**BROWNELL DAM**  
NDS ID NO. 192  
**PENNSYLVANIA GAS AND WATER COMPANY**

**PHASE I INSPECTION REPORT**  
**NATIONAL DAM INSPECTION PROGRAM**

Distribution Unlimited  
Approved for Public Release  
Contract No. DACW31-78-C-0046

Prepared by  
GANNETT FLEMING CORDDRY AND CARPENTER, INC.  
Consulting Engineers  
Harrisburg, Pennsylvania 17105

B. Downstream Face of Auxiliary Spillway

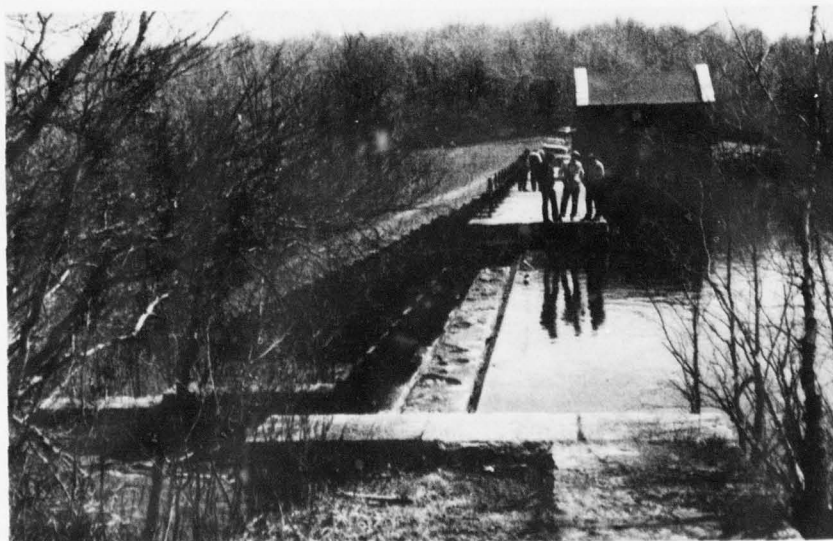
(1) The entire downstream face of the auxiliary spillway (Photograph B) is wet from about 6 feet below the crest. There are white powdery deposits, or efflorescence, over most of the face. The seepage was insufficient to cause flow at the toe

(1) The slight seepage on the downstream face of the auxiliary spillway is of slight concern at the present time. The cause of the calcium-like deposits on the face is unknown but they did not seem to be associated with any potential problems. The corroded handrail could be a hazard to personnel. It could also collect debris during flow over the auxiliary spillway and reduce the discharge.
